Change Bulletin

No: CB010

Description: Bonnet Access Window and Bonnet Bolt Length Change

Tesco Corporation
6204 – 6A Street SE
Calgary, AB. T2H 2B7
Phone: (403) 692 5700
www.tescocorp.com

Figure 1 – Bonnet Access Window (Split Block version shown)

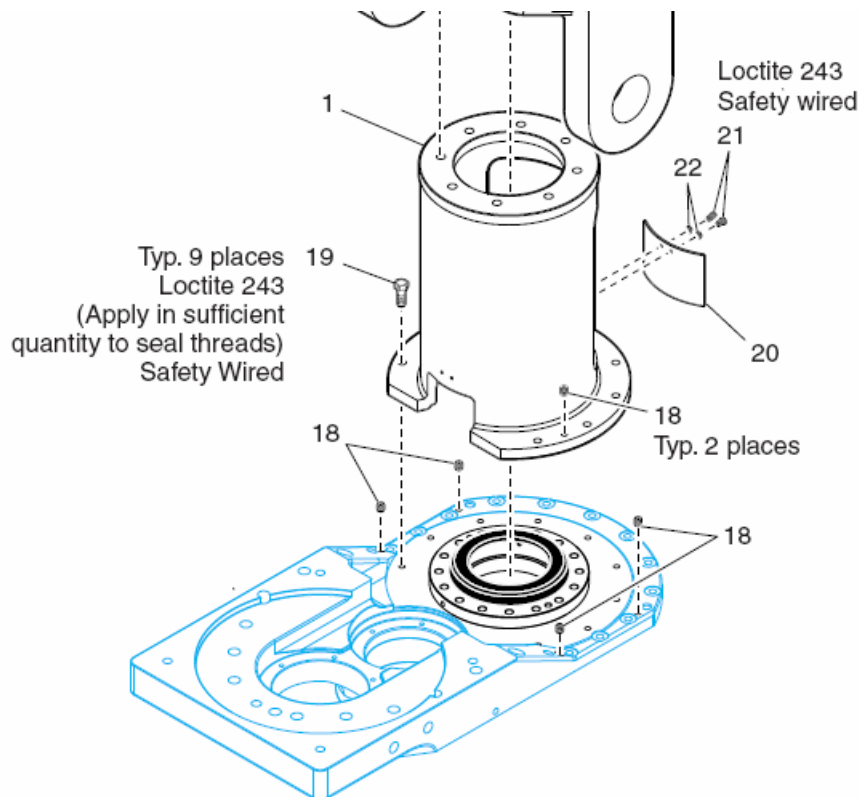
An access window and removable panel has been added to the bonnet on the EMI 400. This change will allow better access to the fittings on top of the gearbox that make up part of the gearbox lubrication system. Figure 1 shows the location of the access window in the bonnet (Item 1) and the removable panel (Item 20).

The bolts that were used to connect the bonnet to the gear box lid (Item 19) were originally specified as 1/2"-13UNC x 1-1/2". The combined thickness of the bonnet flange and flat washer resulted in a thread engagement of approximately 3/8" making this connection susceptible to failure from highly torqued fasteners or impacts to the attached components. This bolted connection has been modified to use 1/2"-13 UNC x 1-3/4" fasteners without a washer to provide an improved connection.

The bonnet access window is a non-essential upgrade that may be added to the top drive when a unit is brought into a Tesco Service Centre for routine maintenance. The modification can be made to existing units by a number of machining/cutting operations including torch cutting and grinding. Please refer to the correct drawings for the specific top drive configuration as follows,

To date only two top drives have experienced a failure of the bonnet connection. The first of these failures was directly associated with an impact event while the second was not conclusive as to cause. Given the very limited occurrence of this problem, it is recommended that the modification be performed during routine maintenance. The corrective action required is to replace the existing 1/2"-13 UNC x 1-1/2" fasteners (PN 3116) with longer 1/2"-13UNC x 1-3/4" fasteners (PN 5967) and to omit the flat washer. When applying Loctite to these bolts make sure to apply around the full circumference of the threads and in sufficient quantity to ensure a water tight seal.
